TUESDAY, NOVEMBER 18, 2014
(COUNCIL CHAMBERS)

1. "State of the Foundation" report from College Park Community Foundation (request of Councilmember Dennis) - Richard Morrison (Chair) and Dave Milligan (Vice Chair)
2. Preliminary Plan and Detailed Site Plan for The Hotel at the University of Maryland – Terry Schum, Director of Planning
3. Recommendation for award of Business Recycling Grant – Loree O'Hagan, City Recycling Coordinator
4. Proposed updates to the City's recycling code – Bob Stumpff, Director of Public Works
5. Discussion of Buy Local efforts – Councilmember Wojahn
6. Revisit the City's "Prohibited continuous parking in excess of 48 hours on public roadways" law - Councilmember Wojahn
7. Discussion of site selection for City Hall and discussion of acquiring a portion of the Stone Industrial site

SUBJECT: Preliminary Plan of Subdivision 4-14009
Detailed Site Plan (DSP) 14022
The Hotel at the University of Maryland

EAST BUILDING ELEVATION
DRAWING NOT TO SCALE

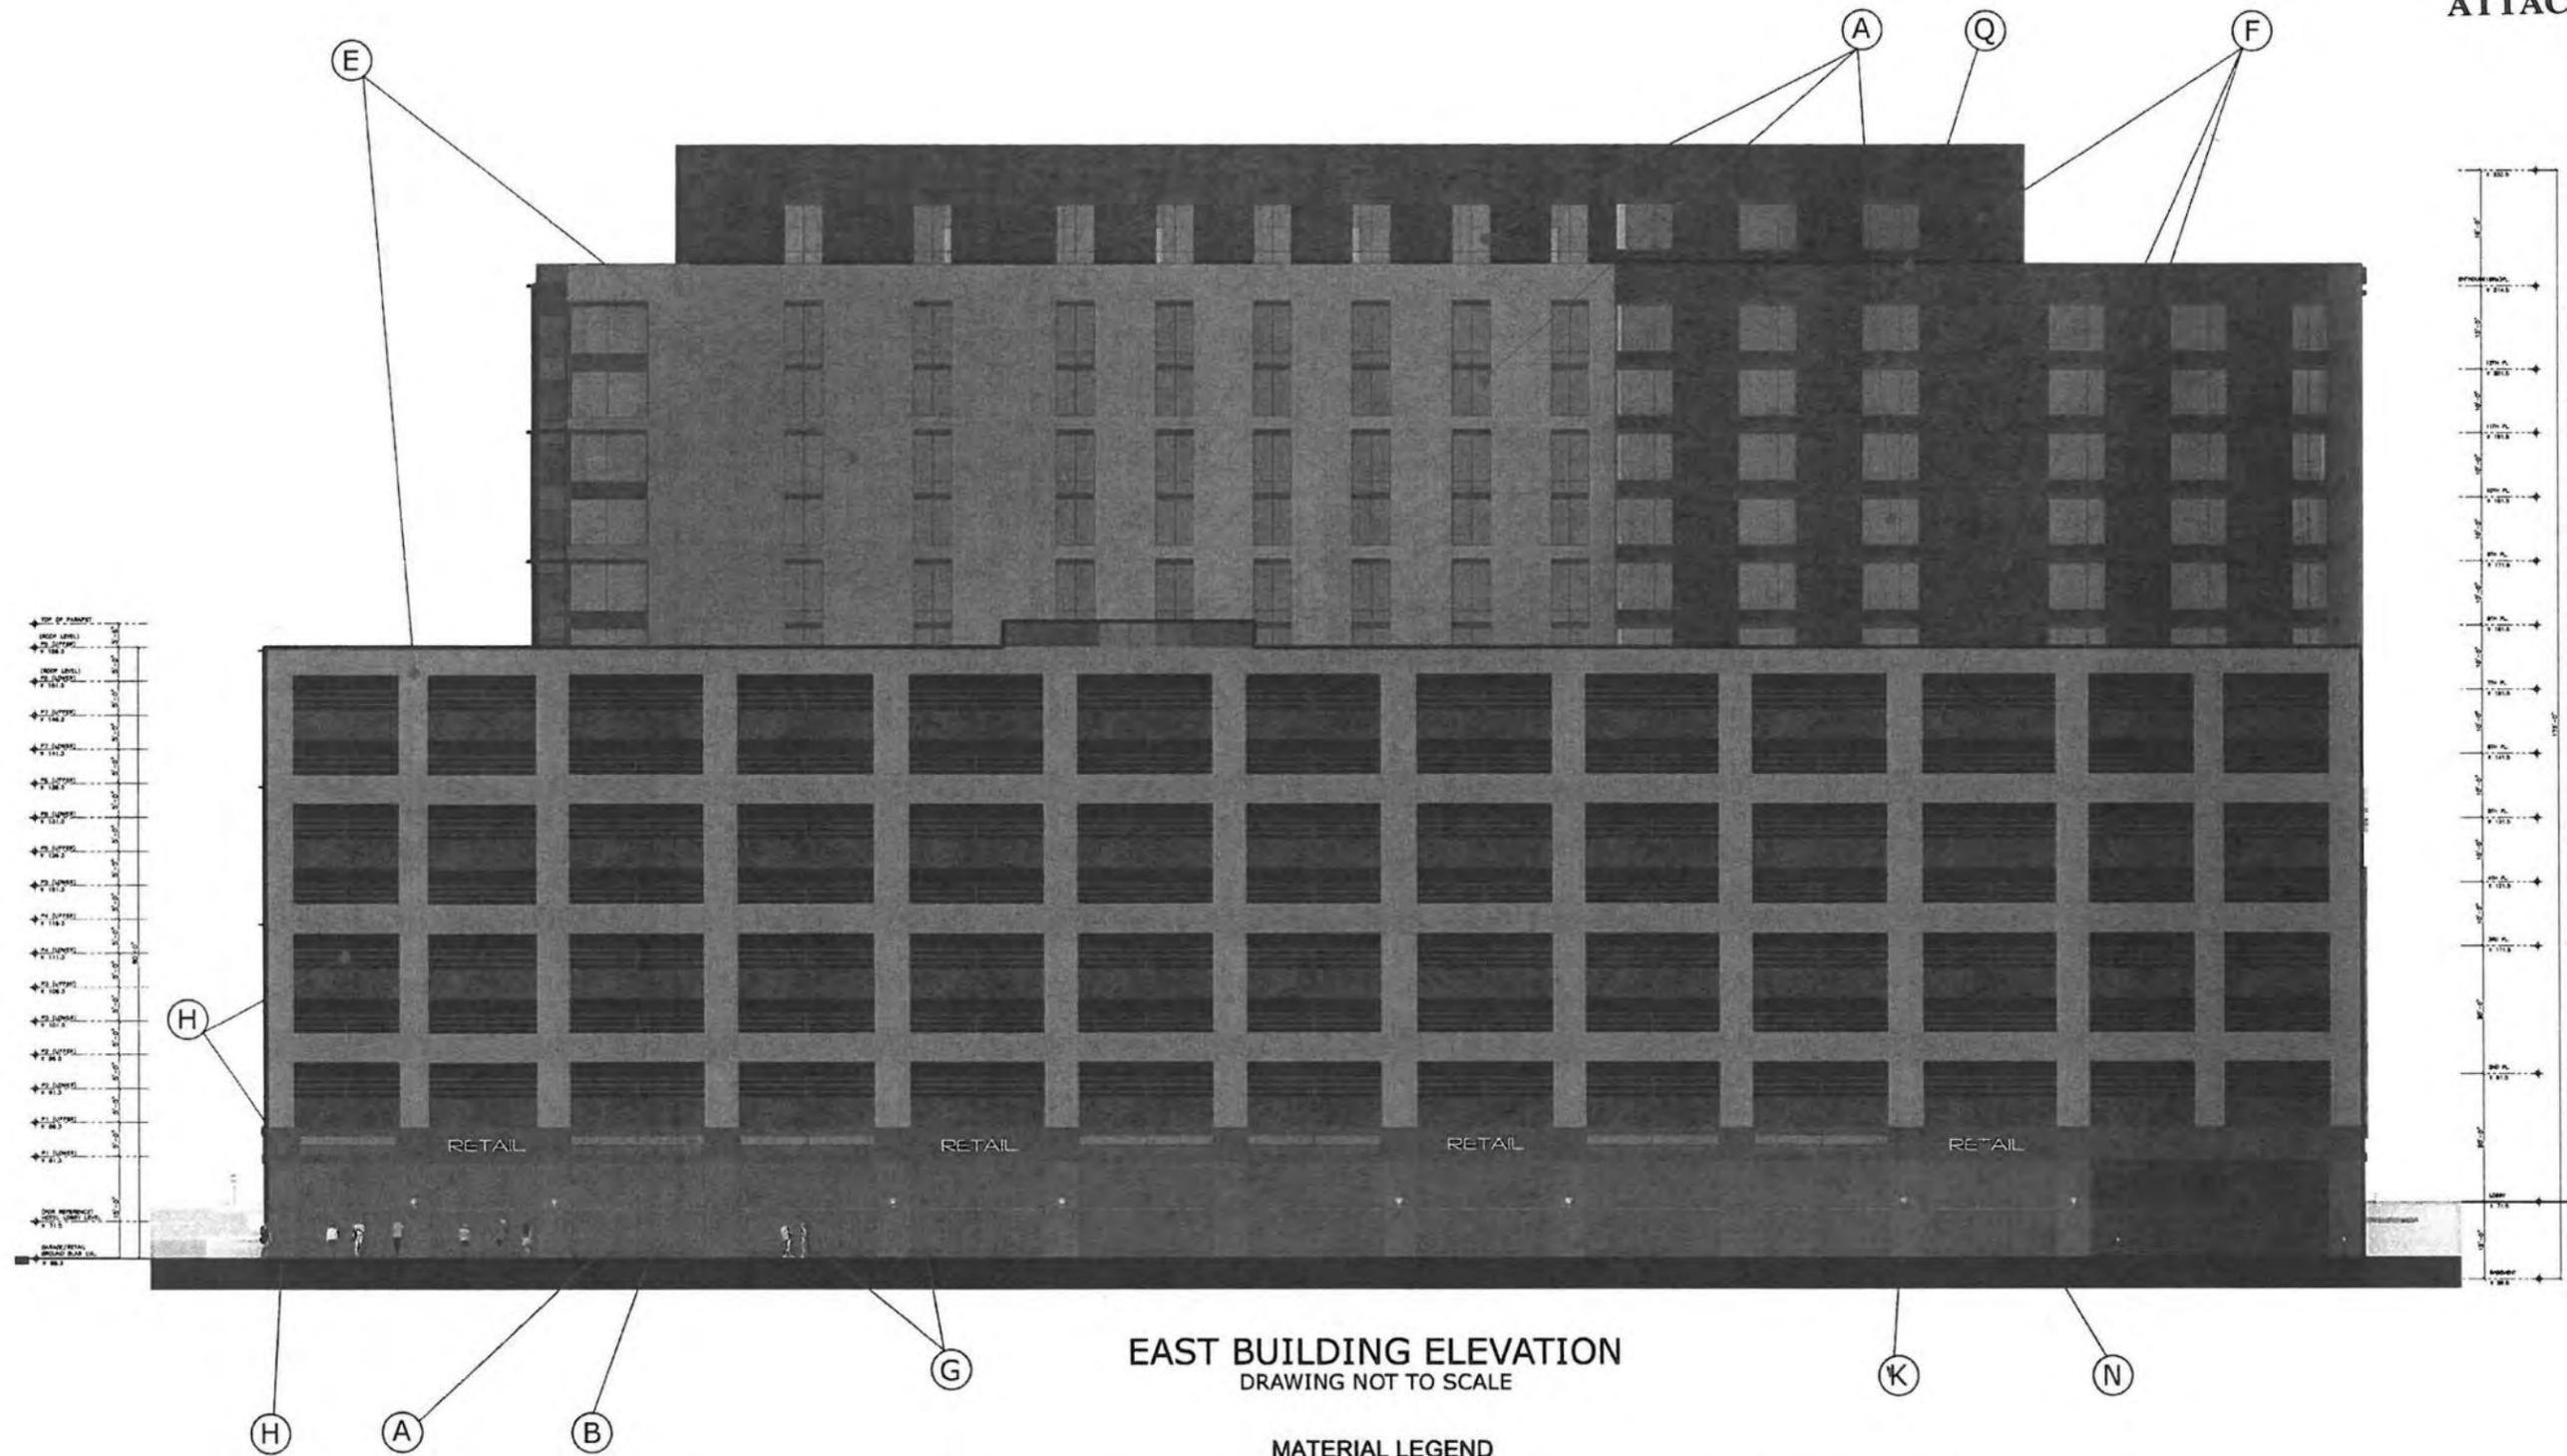
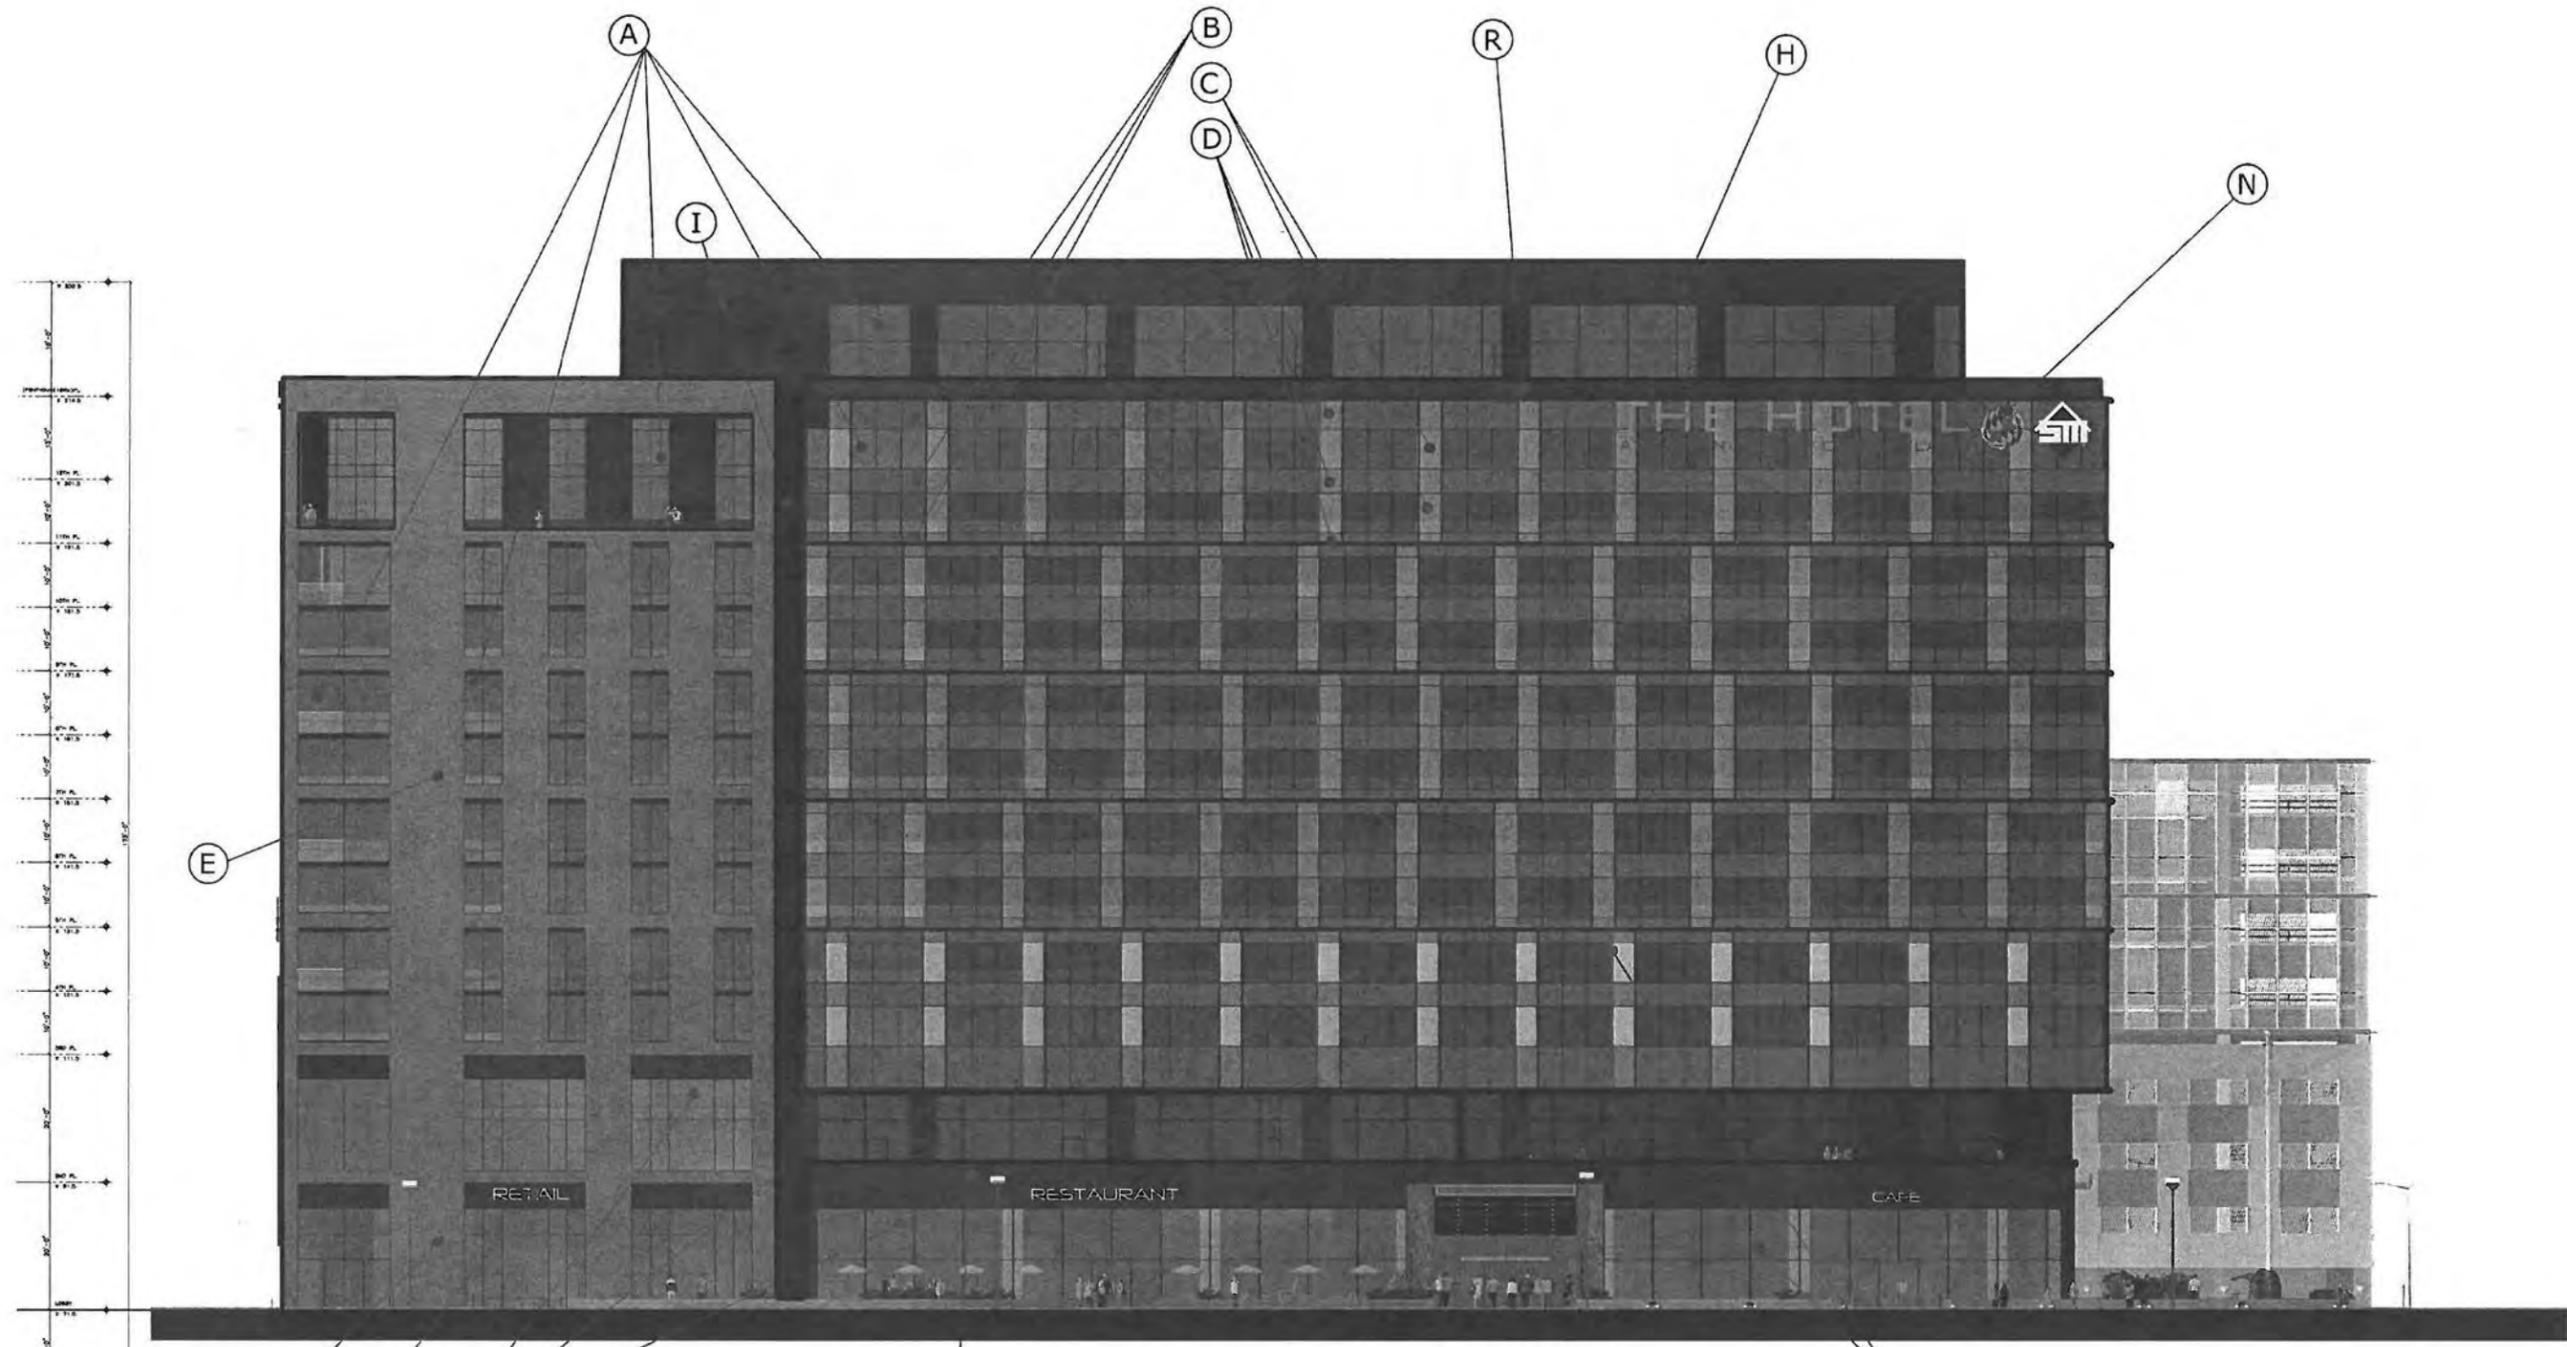
The Part 77 Horizontal Surface is 198 feet Above Mean Sea Level (AMSL) at this location. The hotel is proposed to be 233 feet AMSL which exceeds the FAA and COMAR standard by 35 feet. This has the potential to negatively affect the operation of the College Park Airport. It is our understanding that the MAA will have "no comment" on this application and the FAA is still conducting their review. We are in receipt of a letter from the College Park Airport Authority (Attachment 9) recommending that the height of the hotel be no greater than 198 feet above mean sea level or 150 feet above ground level and that the applicant obtain a "no hazard" determination from the FAA and MAA. Staff supports the building height modification subject to these determinations from FAA and MAA.

4. Electronic Message Center (EMC) signs. The applicant is proposing two 16.67-foot tall by 8-foot wide Electronic Message Center (EMC) signs located on the North and South Elevation of the building at a height of 80-feet. There is no mention of this type of signs in the Sector Plan. US1 is a very busy highway with University buildings and activities located along both sides of the road. Moreover, there is much pedestrian crossing activity at unauthorized locations. City staff is concerned that Electronic Message Center signs flashing messages could create further distractions to drivers on US 1 and create unsafe conditions. Therefore, City staff recommends that the Electronic Message signs not be permitted.

- b. A color and materials board.
3. Prior to signature approval, the Applicant shall revise the sign plan to:
 - a. Eliminate all electronic message center signs.
